**Village of Itasca**  
**Community Development Department**

**MEMORANDUM**

<b>TO:</b>	President Jeff Pruyn Village Board of Trustees	<b>RE:</b>	PC# 19-013 Quadrangle Development Company 870 N. Arlington Heights Road
<b>FROM:</b>	Kon Savoy, AICP Senior Planning Consultant	<b>COTW:</b>	September 3, 2019
<b>CC:</b>	Shannon Malik Jarmusz, AICP CD Director	<b>ENCL:</b>	Plan Commission Staff report, associated documents, and public communications

**RE:** Option Care – 870 Arlington Heights Road  
Preliminary Engineering Review #1  
REL# 19-R0741

# Building Elevations

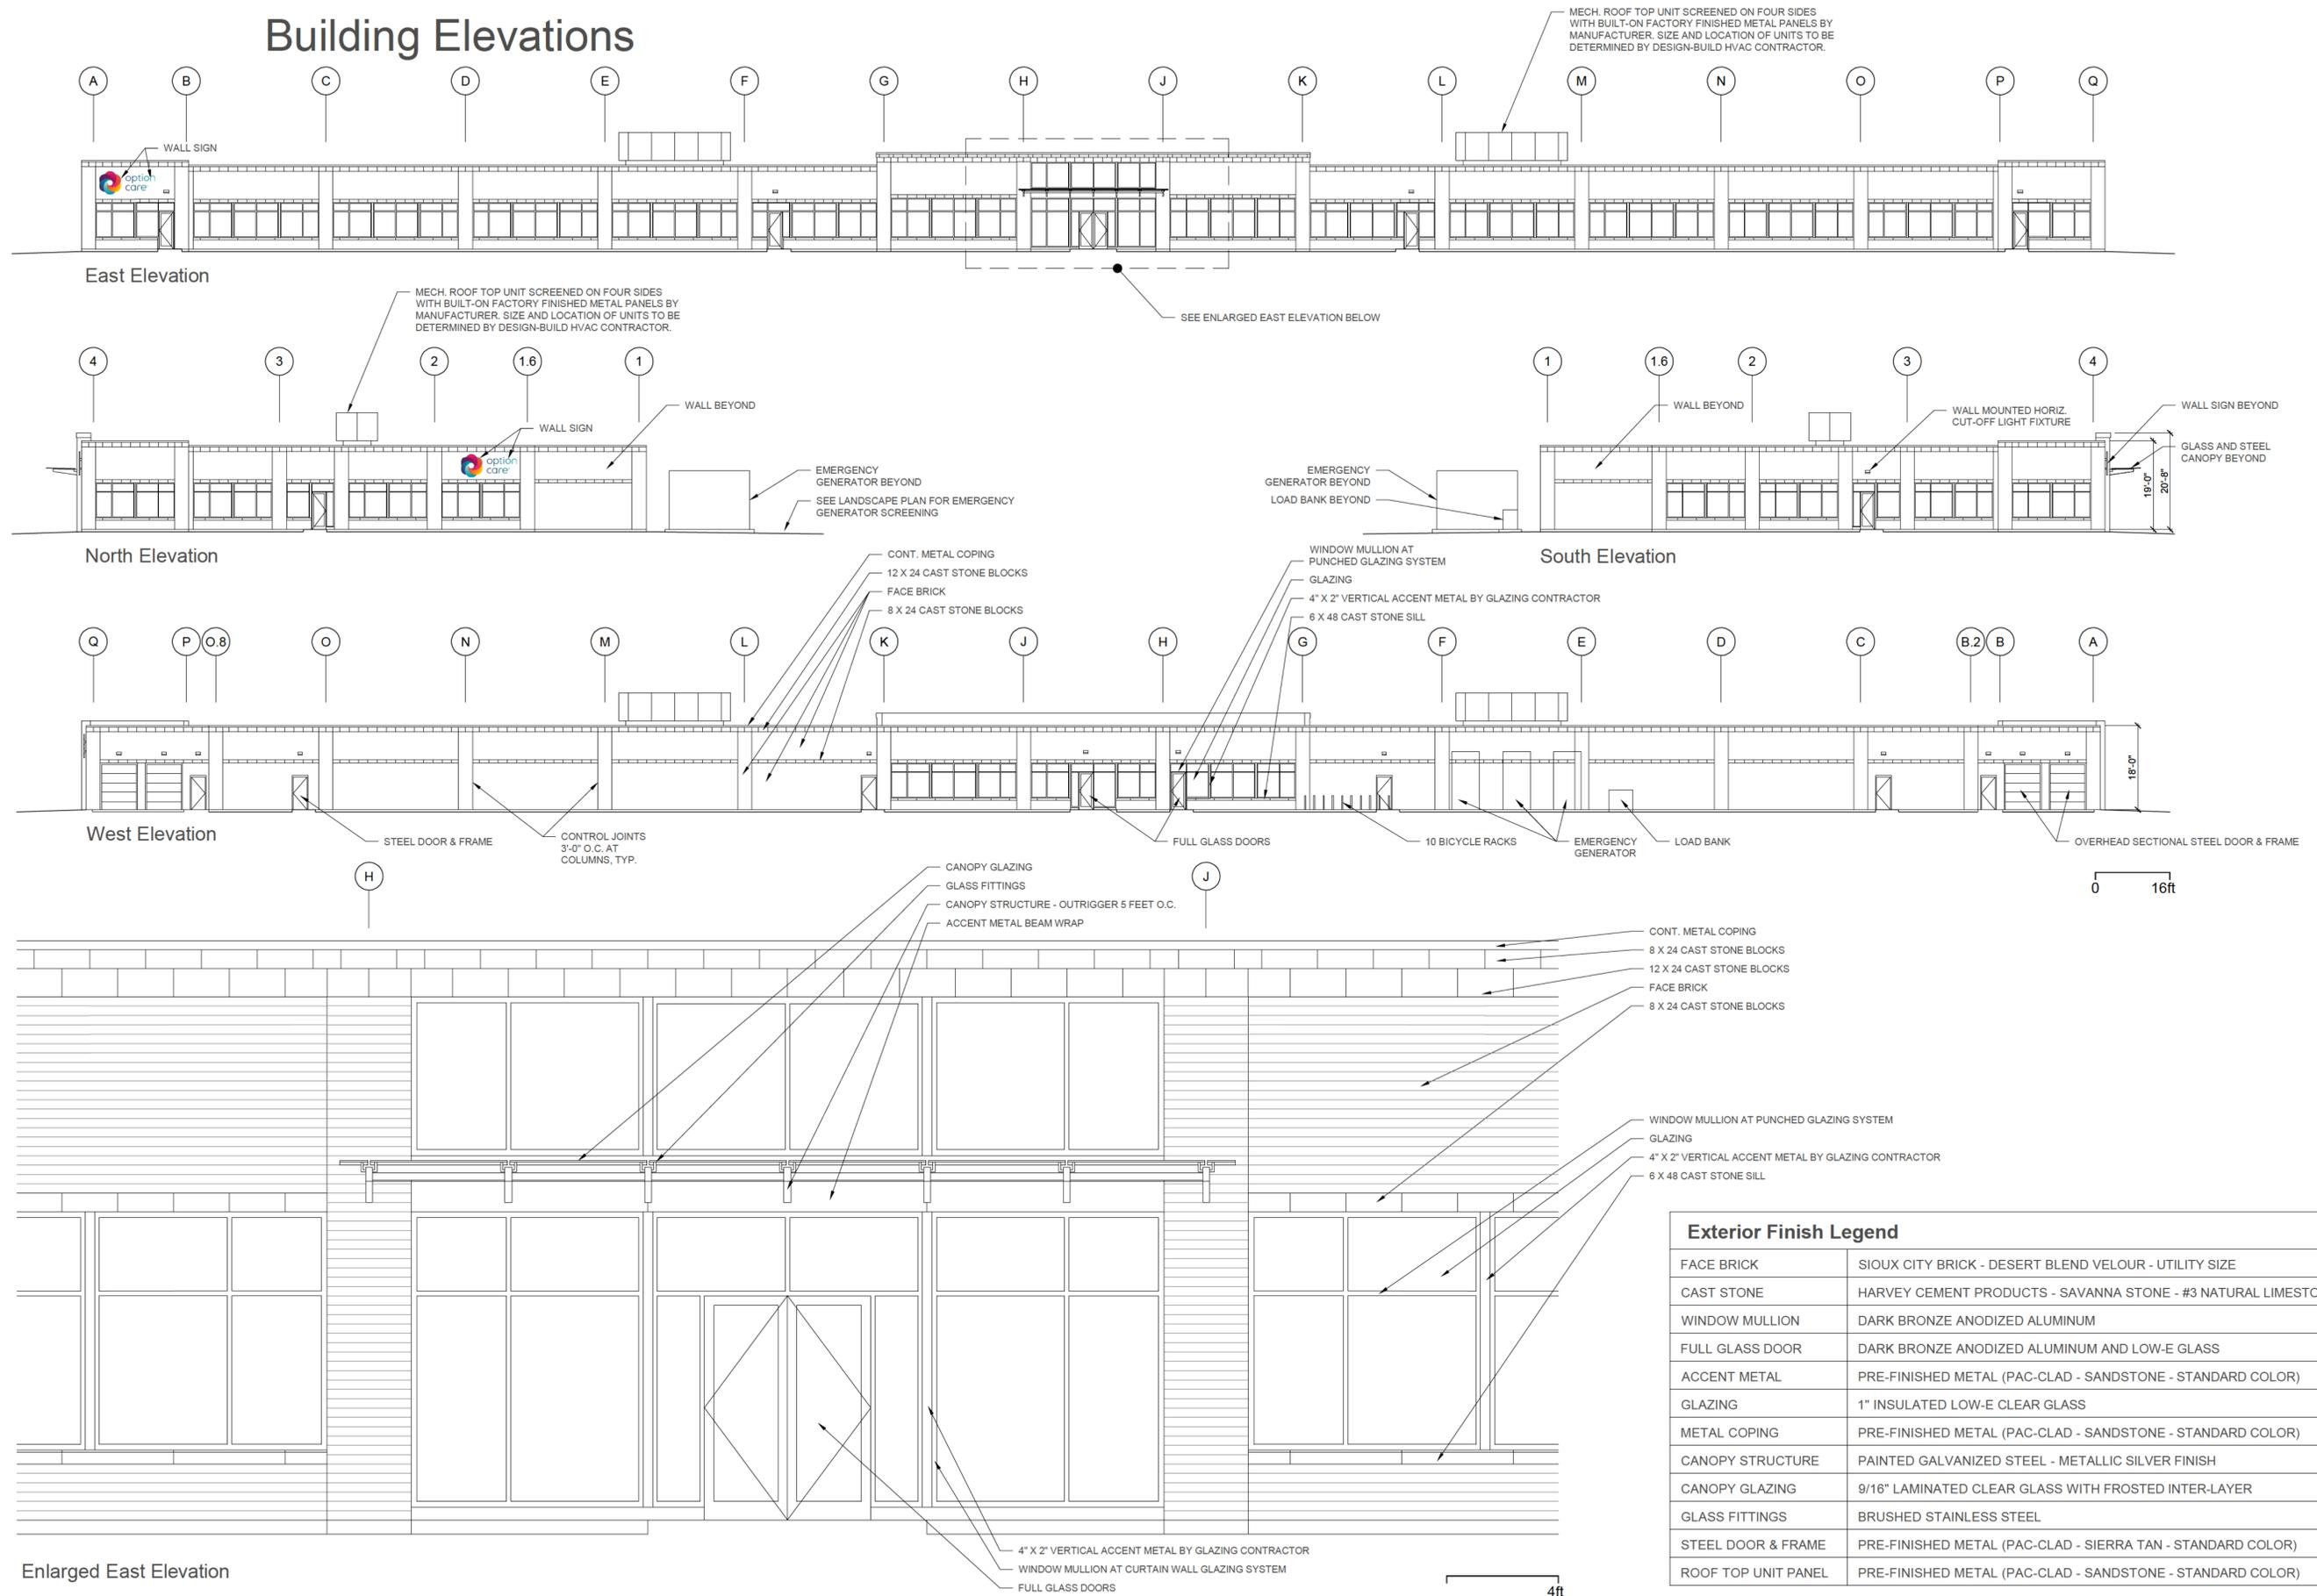
14. Revise building elevations to provide variation in the roofline, with consideration of design features in areas where roof-top mechanical equipment is planned. *Comment: the developer has complied*

# Building and Site Signage

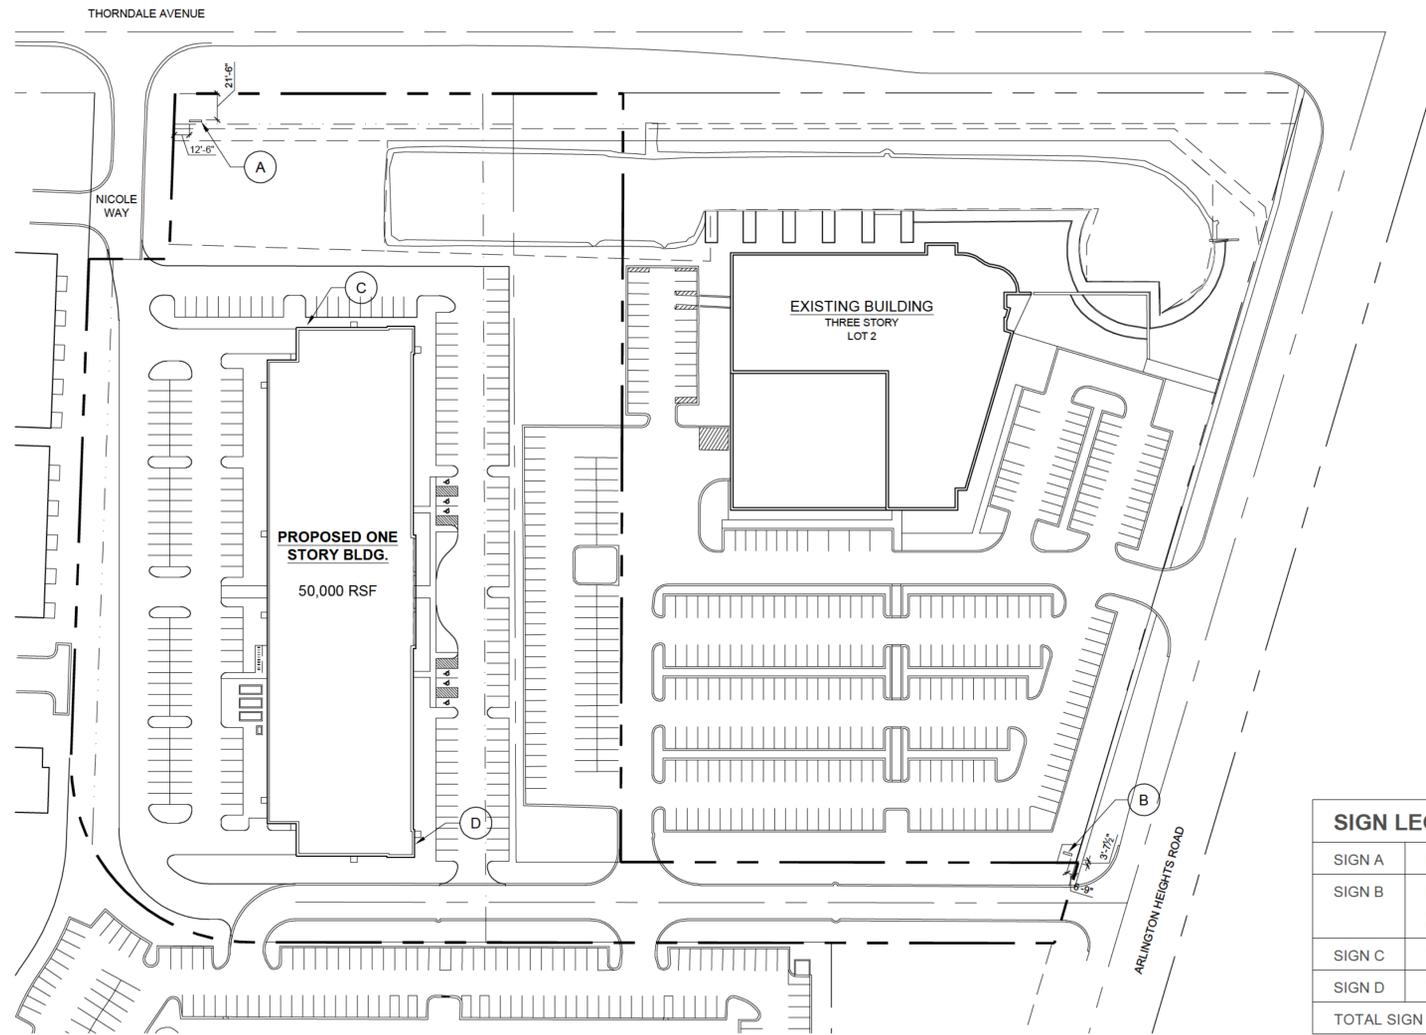
15. The sign plan shall show the setbacks of each ground sign from adjacent property lines. *Comment: the developer has complied*
16. All light levels along the north, west, and south lot lines shall be reduced. *Comment: the developer has complied*

**L1.0**

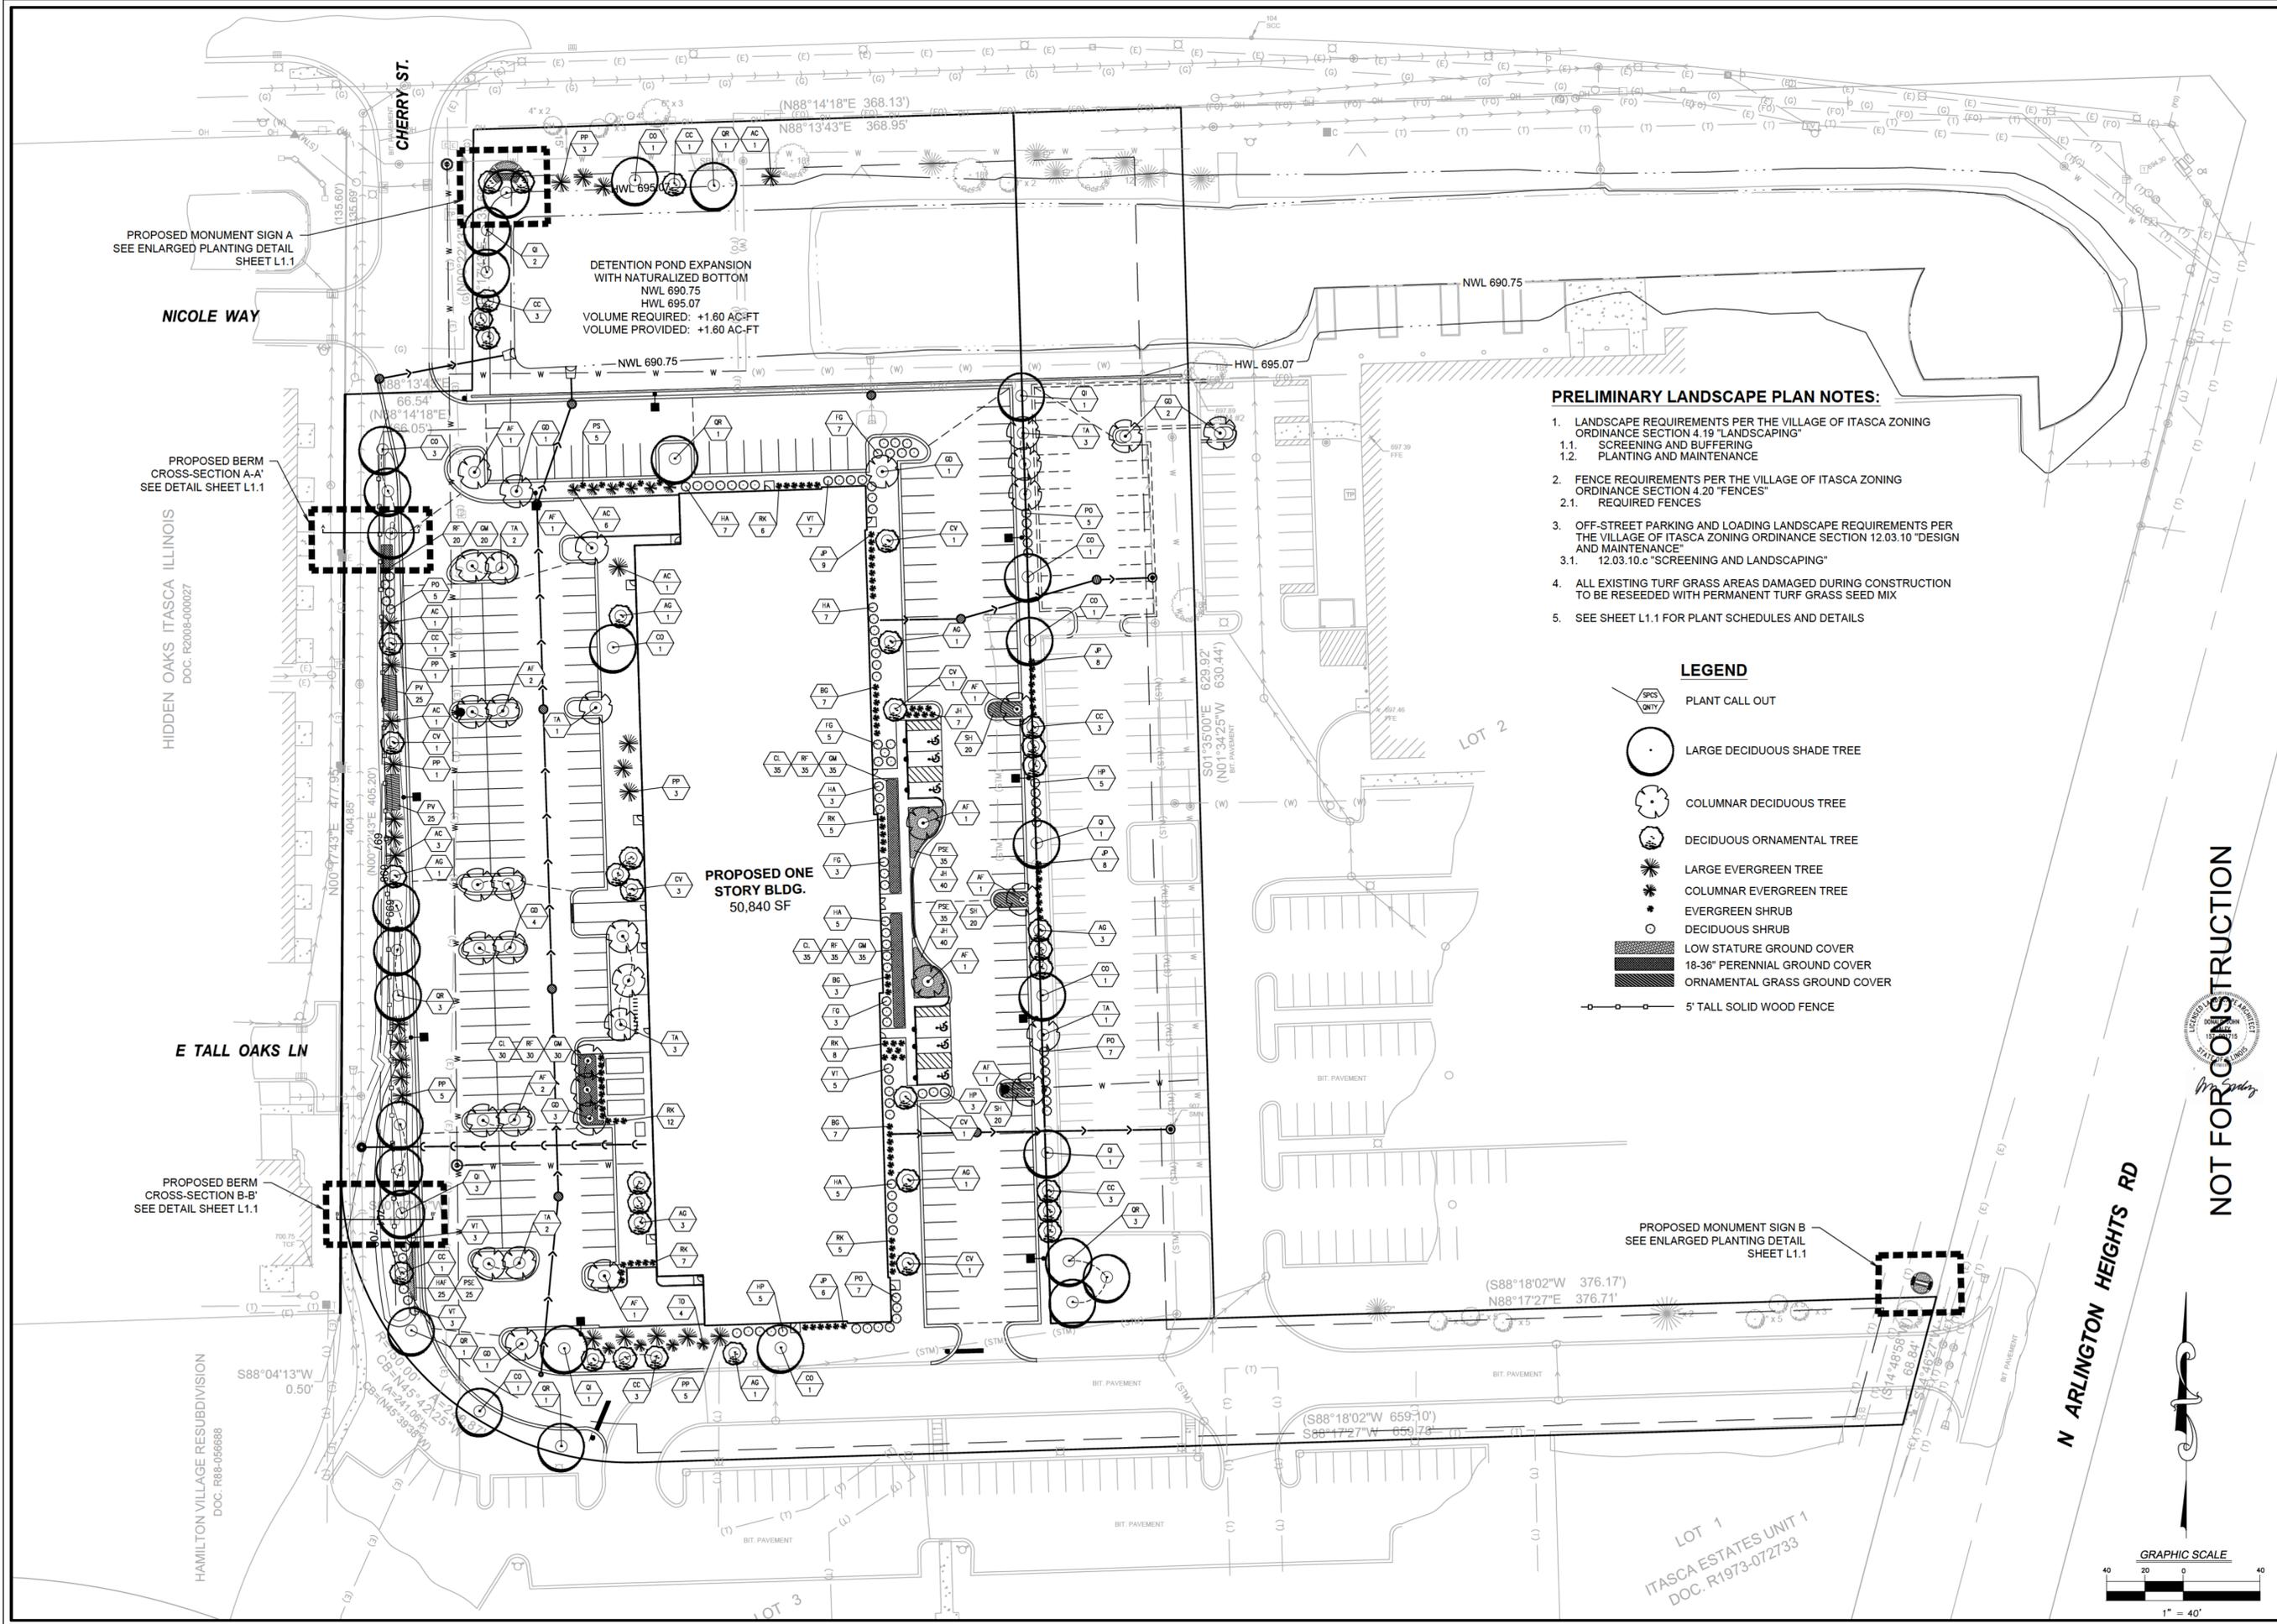
6. The total impervious surface shall be provided in table form. *Comment: the developer has complied*
7. Provide a cross-section detail of the berm, with proposed landscaping, for both the northern and southern sections due to the width difference. *Comment: the developer has complied*

8. Increase the plant density on the berm, by adding shrubs, ornamental trees, and perennial flowers to add variety and interest. *Comment: the developer has complied*

9. Add additional plants about the high-water line in the detention areas. *Comment: the developer has complied*
10. Add a shade tree in the parking island on the north side of the building. *Comment: the developer has complied*

11. Expanding plantings along the east property line. *Comment: the developer has complied*
12. Providing screening around the power generator. *Comment: the developer has complied*

The current site plan only provides 1.1 ac-ft of proposed storage. The site plan shall be revised to provide a minimum of 1.8 ac-ft, along with the required PCBMPs per the current Countywide ordinance.
